Access Compliance Report

Intersection ID: 42503	Main Street: DOSTER_AV	Cross Street: TOLLESON_AV	Location: NE
ADA ID: 61D3F6093887	Ramp Type: Perp	Initial Pass/Fail: Fail	Overall Compliance: No
Severity Score: 8.75			
Codes/Mitigation Info/Possible Solution		Field Measurements/Component Compliance

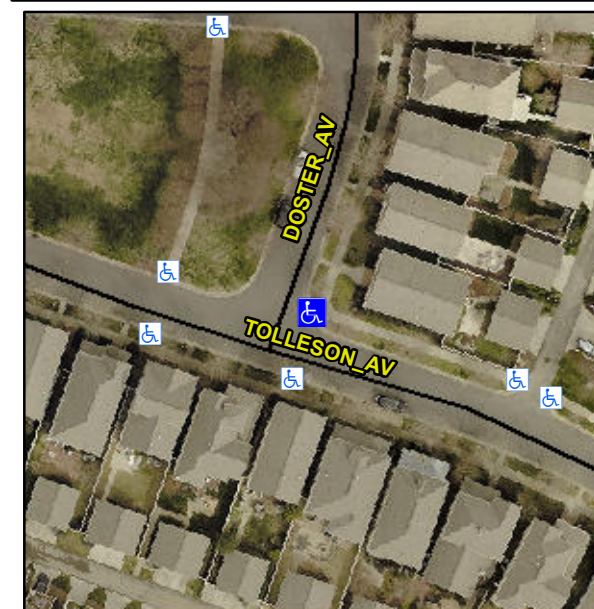
R304.5.1

Compliance	Description	Data	Compliance	Description	Data
N/A	Ramp Length (in)	69.0	Yes	Ramp Slope (%)	5.5
No	Ramp Width (in)	47.0	Yes	Ramp XSlope (%)	0.3
N/A	Flare Type LT	N/A	N/A	Flare Type RT	N/A
N/A	Flare Slope LT (%)	N/A	N/A	Flare Slope RT (%)	N/A
N/A	Flare Traversable LT?	N/A	N/A	Flare Traversable RT?	N/A
N/A	Landing Length (in)	N/A	N/A	DWS Provided?	N/A
N/A	Landing Width (in)	N/A	N/A	DWS Contrast?	N/A
N/A	Landing Slope (%)	N/A	N/A	DWS Length (in)	N/A
N/A	Landing X Slope (%)	N/A	N/A	DWS Full Width?	N/A
N/A	Landing Curb? (Y/N)	N/A	N/A	DWS Offset (in)	N/A
N/A	Shared Landing?	N/A			
N/A	Gutter Ponding?	N/A	N/A	Gutter Slope (%)	N/A
N/A	Gutter Lip Ht (in)	N/A	N/A	Gutter X Slope (%)	N/A
N/A	Painted X Walk1?	No	N/A	Painted X Walk2?	N/A
	X Walk 1 Direction	To NW		X Walk 2 Direction	N/A
N/A	X Walk 1 Width (in)	N/A	N/A	X Walk 2 Width (in)	N/A
	X Walk 1 Slope (%)	2.5		X Walk 2 Slope (%)	N/A
	X Walk 1 X Slope (%)	0.5		X Walk 2 X Slope (%)	N/A

Remove & Replace Entire Ramp.
